**TOWN OF NEWBURGH  
PLANNING BOARD  
TECHNICAL REVIEW COMMENTS**

**PROJECT NAME:** ATHBOY ROAD 4-LOT SUBDIVISION  
**PROJECT NO.:** 24-36  
**PROJECT LOCATION:** SECTION 8, BLOCK 1, LOT 105  
**REVIEW DATE:** 29 MAY 2025  
**MEETING DATE:** 5 JUNE 2025  
**PROJECT REPRESENTATIVE:** CHRIS TERRIZZI, P.E. - CM TERRIZZI ENGINEERING, PLLC

### EROSION & SEDIMENT CONTROL MEASURES

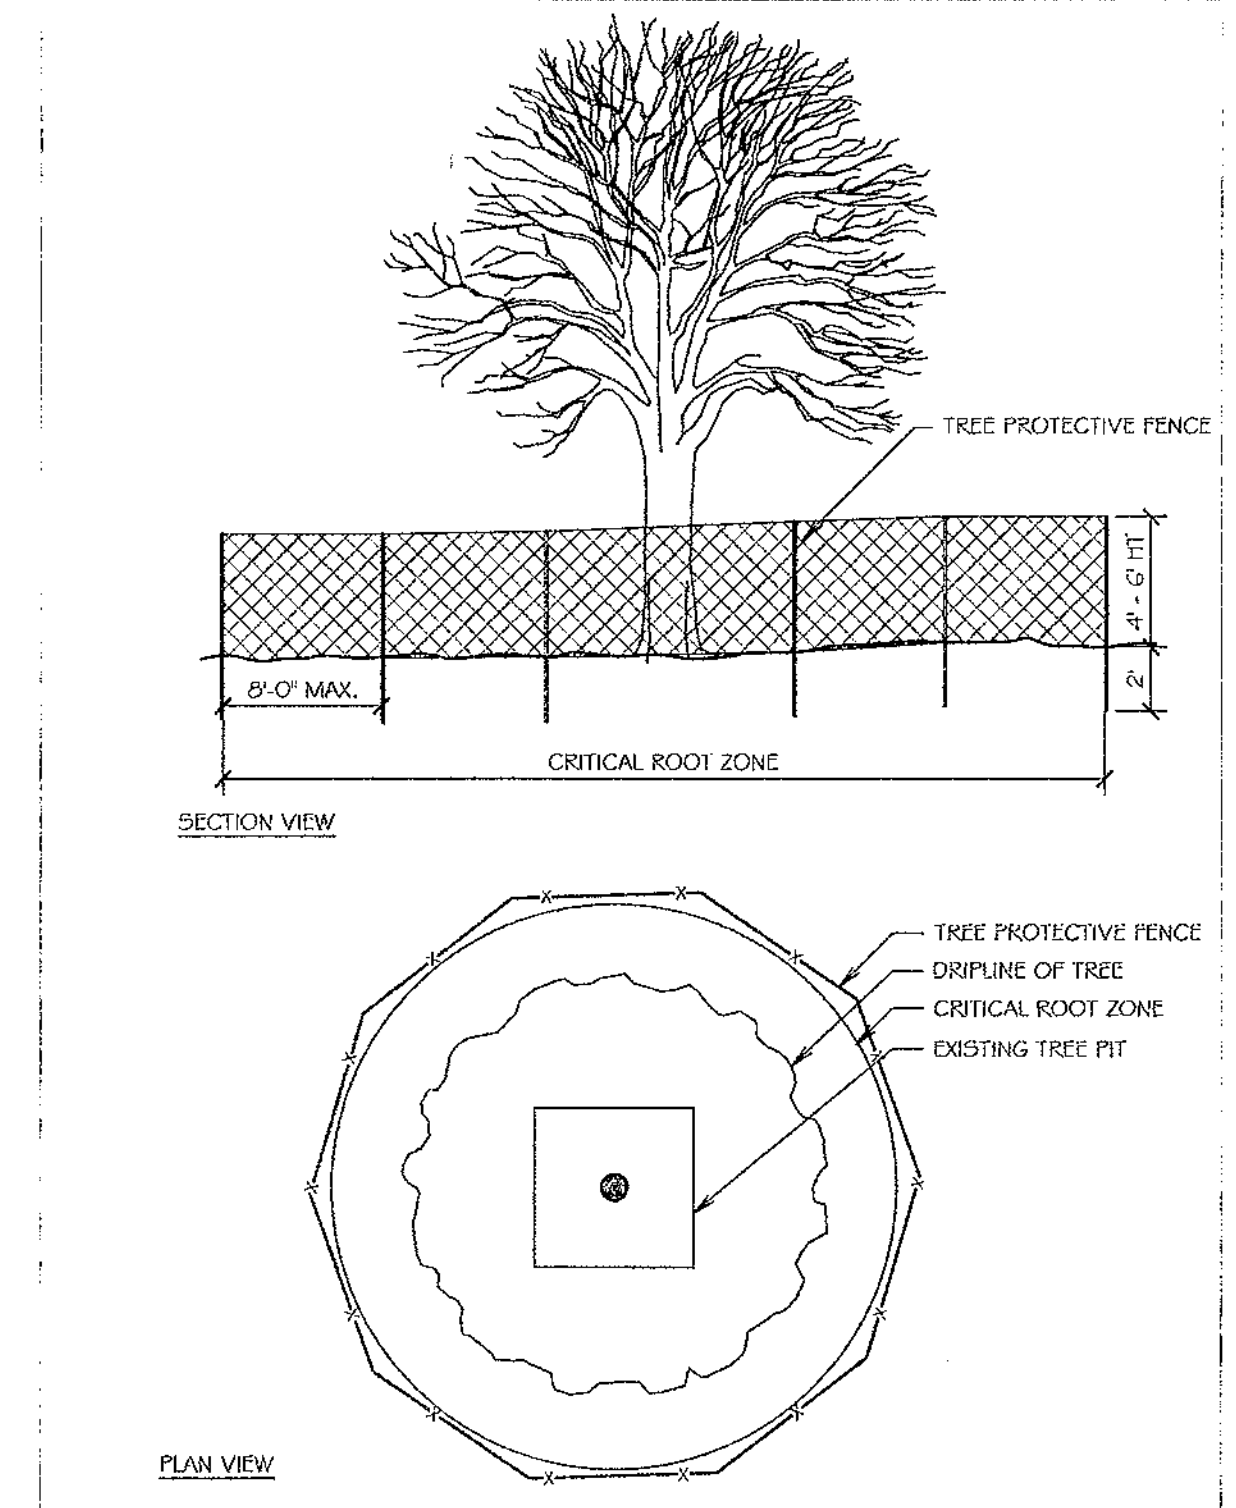
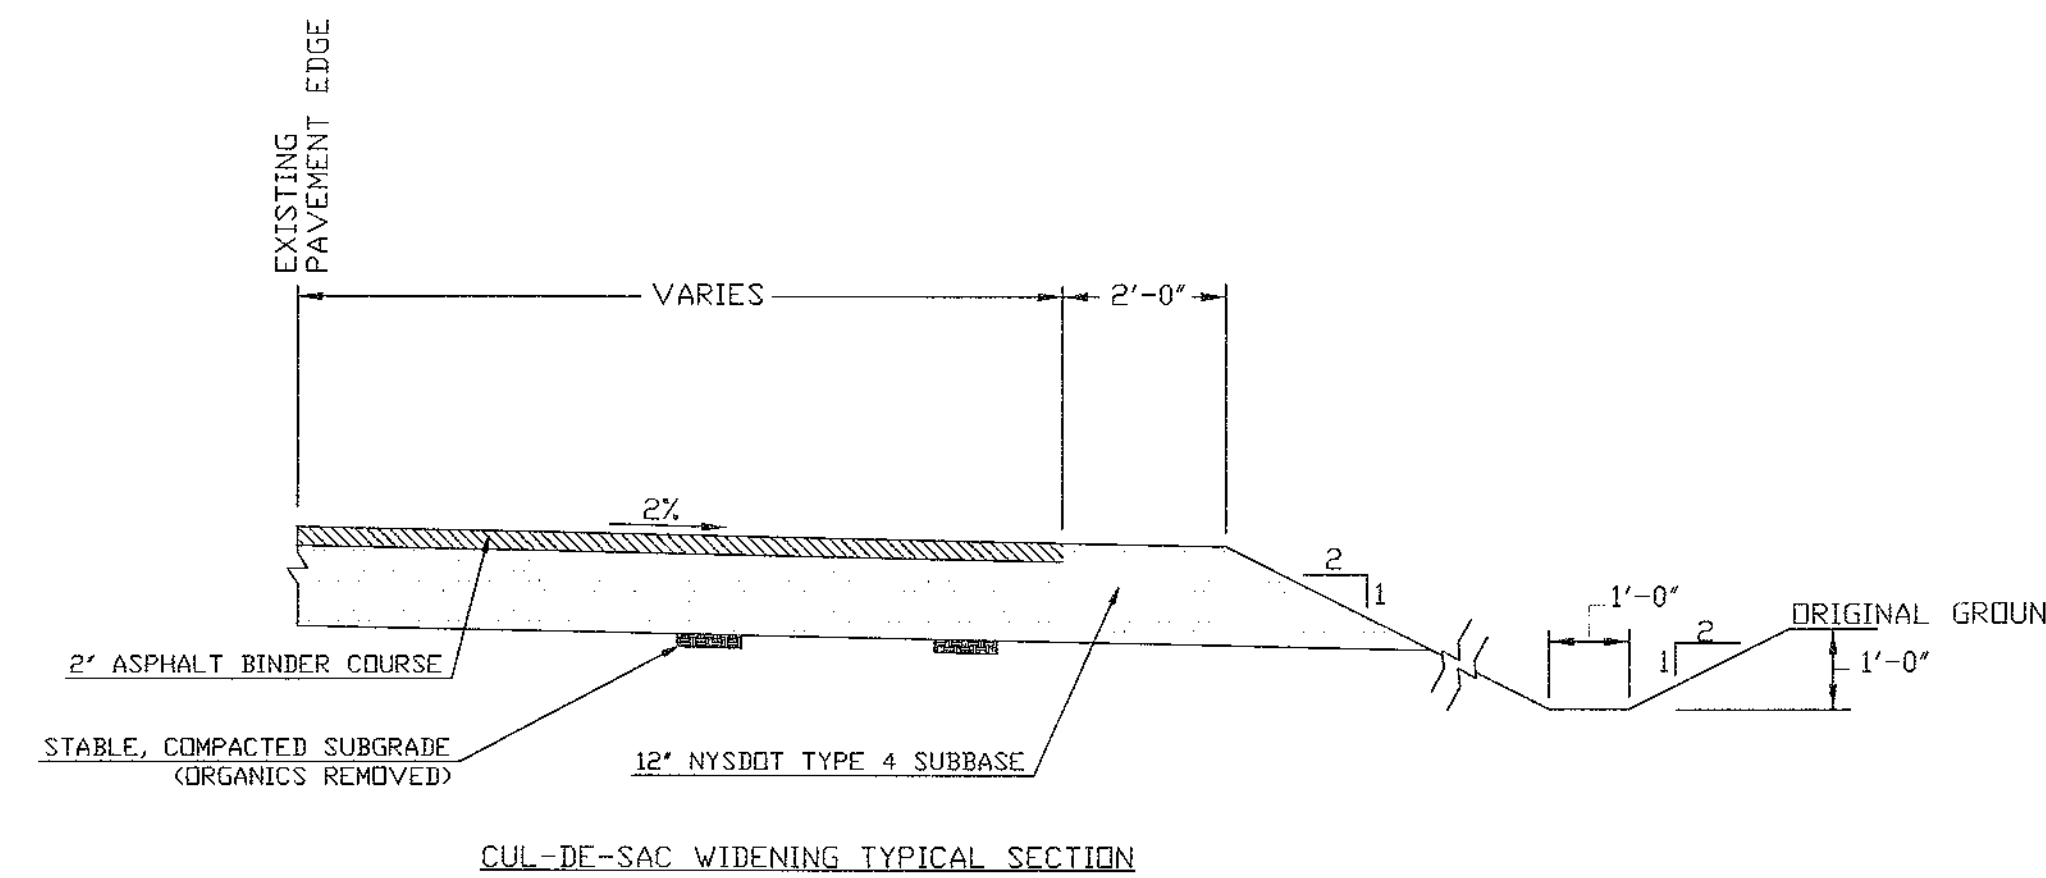
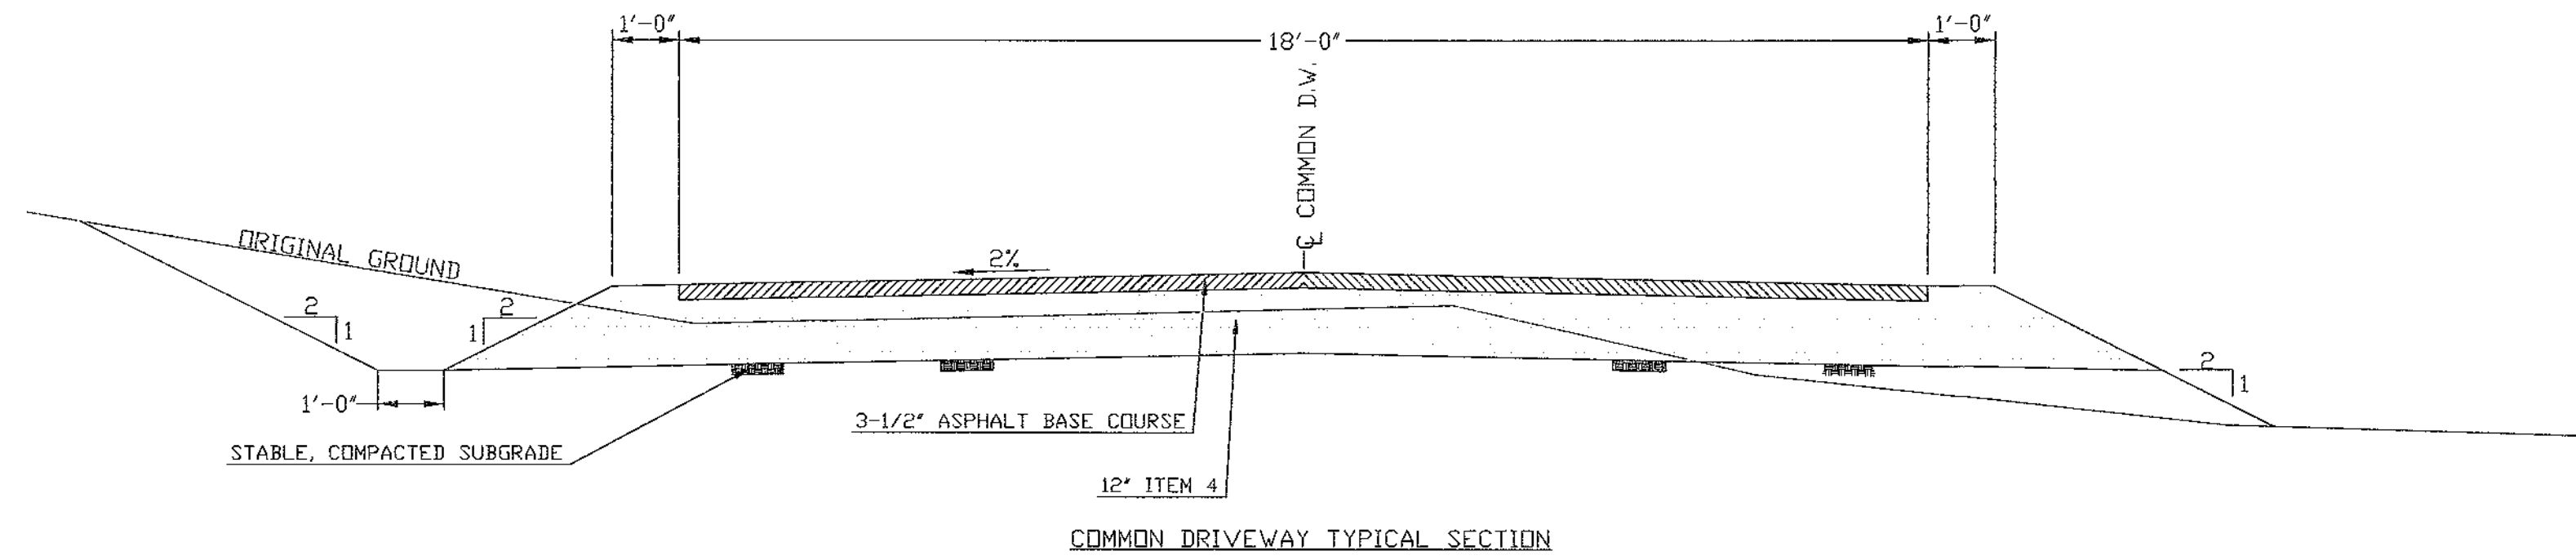
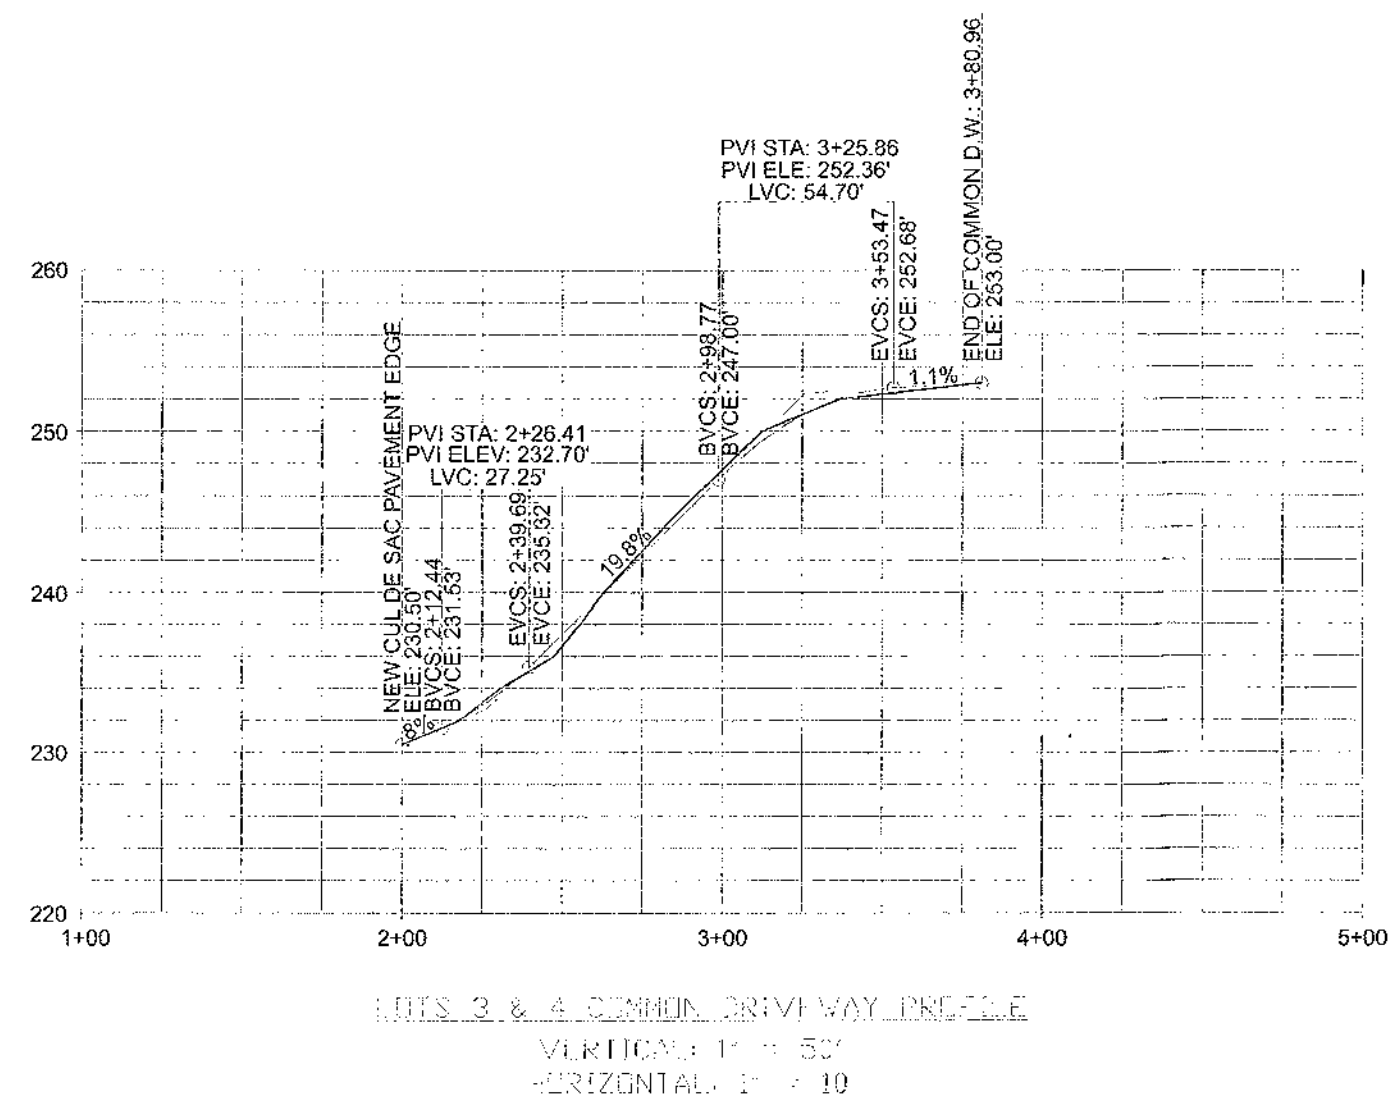
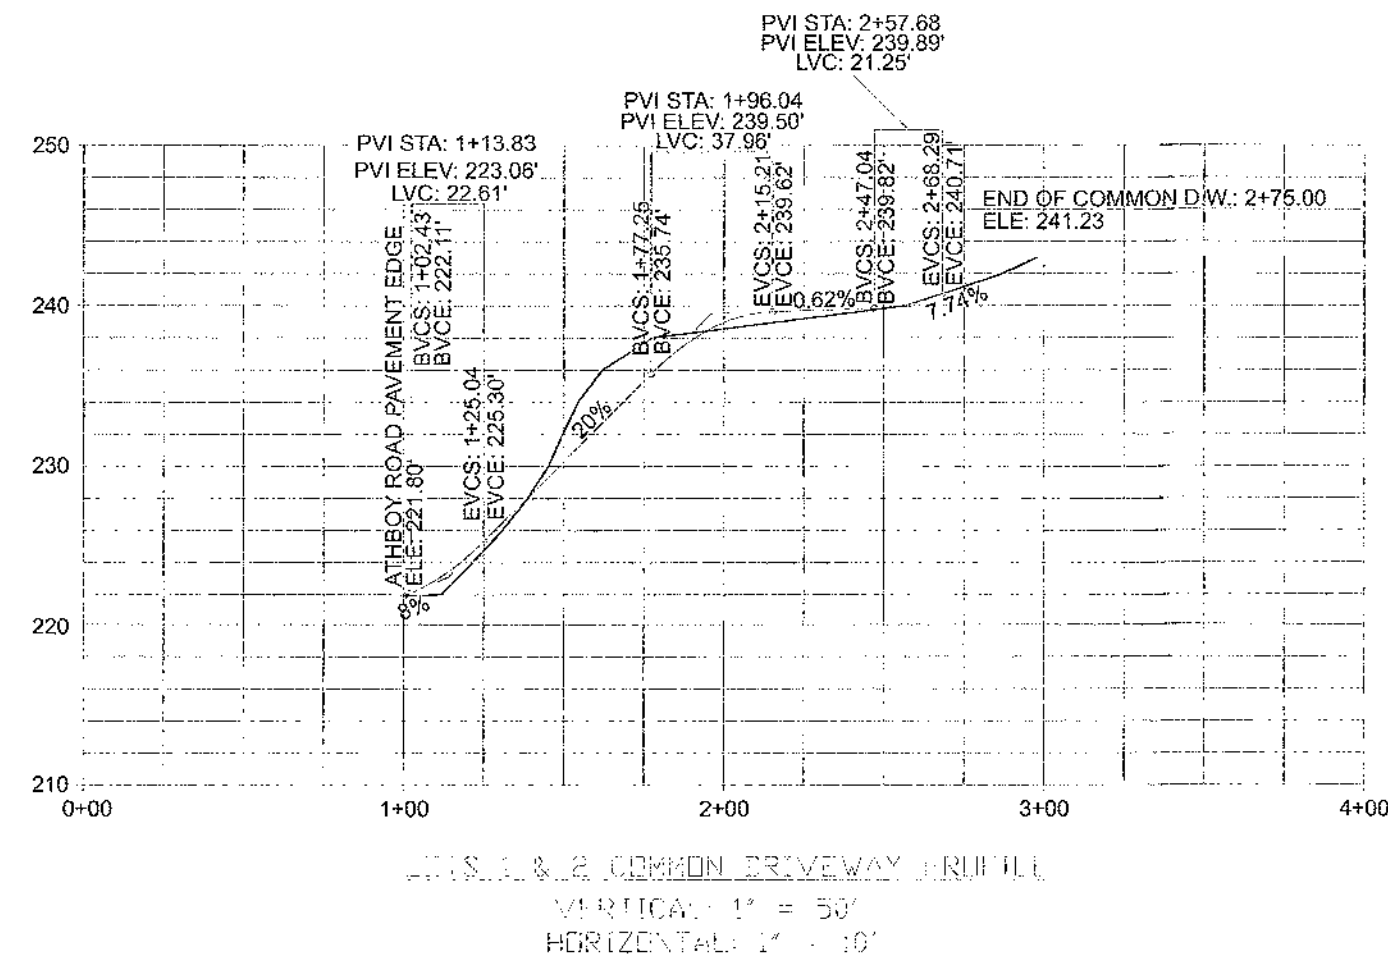
2. The New York State Department of Environmental Conservation issued a response to the Lead Agency determination identifying a work window from April 1<sup>st</sup> to November 30<sup>th</sup>, on the project site to reduce impacts to over wintering Bald Eagles. Notes should be added to the plans.
